#### 8008 Wisconsin Avenue, Project Plan 920150020, Pre-Preliminary Plan 720150160

**Staff Report Date:** 6/5/15

Pre-Preliminary Plan Application: Binding advice on the configuration of right-of-way along the subject

Proposed right-of-way configuration at the intersection of Wisconsin Avenue and Cordell Avenue. The proposed easement area is shaded (yellow). The triangular area of the easement adjacent to the intersection is the area provided in lieu of 20-foot truncation.

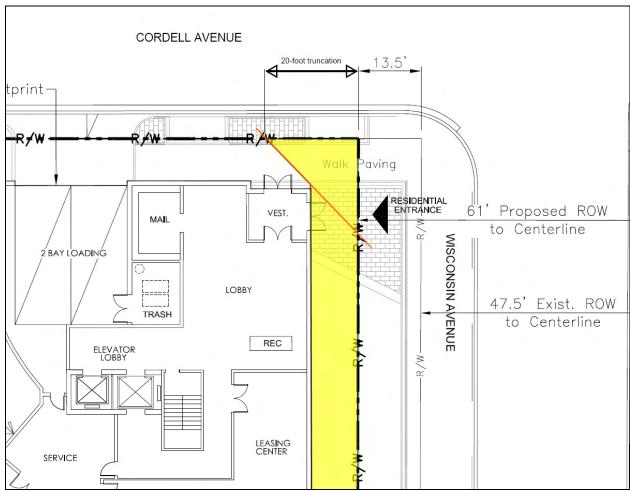
The applicant is also proposing to provide no truncation of the right-of-way at the intersection of Wisconsin Avenue and Cordell Avenue, but to provide an area in the MDSHA easement that would be equivalent to a 20-foot truncation. Full truncation at this intersection is not necessary because adequate sight distance exists. The intersection is signalized, which further enhances its safety and addresses the concern for sufficient space within the right-of-way to place traffic signal equipment. Providing full truncation would negatively impact the design of the proposed project and the provision of the required public use space by further reducing the size of the already constrained subject property. Providing the equivalent of truncation by way of the easement instead of right-of-way dedication will allow the building to project above and the garage to project below a portion of the truncation area. In order to ensure that the easement area remains functionally equivalent to truncation, the staff recommendation includes a condition of approval that requires that the applicant not place anything in the area that otherwise would have been the 20-foot truncation that would obstruct site distance or pedestrian movement.

For these reasons, Staff recommends that the Planning Board find that the proposed modified truncation in this location is appropriate at these intersections.
